# SERVICE BULLETIN

M1559 2022-08-02

## M1559: REVOLUTION MAX ECM UPDATE

Figure 2. 12 V and 1.2A Output

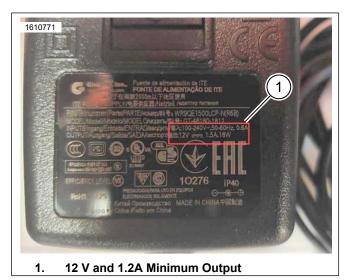
- See Figure 2. The external power adapter must have an output of at least 12 V and 1.2 A. This includes the power adapter included with the TL-3 or the adapter for the DT II.
- The vehicle battery should be fully charged prior doing the software update.
- Have a battery tender connected to the battery while performing software update.
